Consolidated Guidance About Materials Licenses

Program-Specific Guidance About Commercial Radiopharmacy Licenses

Final Report

Figure 8.4 Typical PET Radiopharmacy Diagram

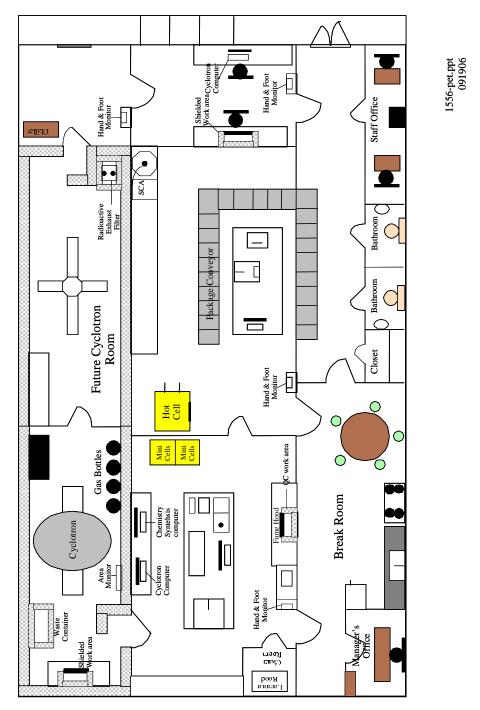
Location	Subject	Comment
Section 8.9.2 (Page 8-32)	Equipment	Figure 8.4 should appear in Section 8.9 not 8.10; Figure 8.4 should be moved to page 8-31 and the information on page 8-31 should be moved to page 8-32.

NRC Staff Response: Figure 8.4 has been moved into Section 8.9.2, "Facilities and Equipment for PET Radiopharmacies."

Figure 8.8 Use of Appropriate Shielding.

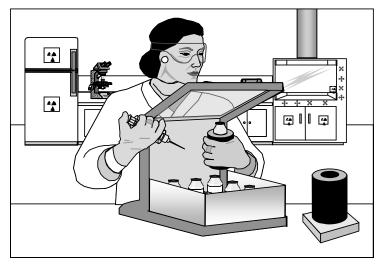
Location	Subject	Comment
Section 8.10.6 (Page 8-45, Figure 8-8)	Use of Appropriate Shielding	The picture intends to show the use of appropriate shielding in a nuclear pharmacy operation. Compared to actual nuclear pharmacy operations, it suggests a situation that does not employ best practices with regard to ALARA. For example, there are multiple unshielded containers in proximity to the extremities and no evidence of any remote or extended handling devices within reach. The handling is also done on a bench top that would be unacceptable for dispensing of radiopharmaceuticals. This picture should be left out of the guidance or replaced with a more acceptable example.
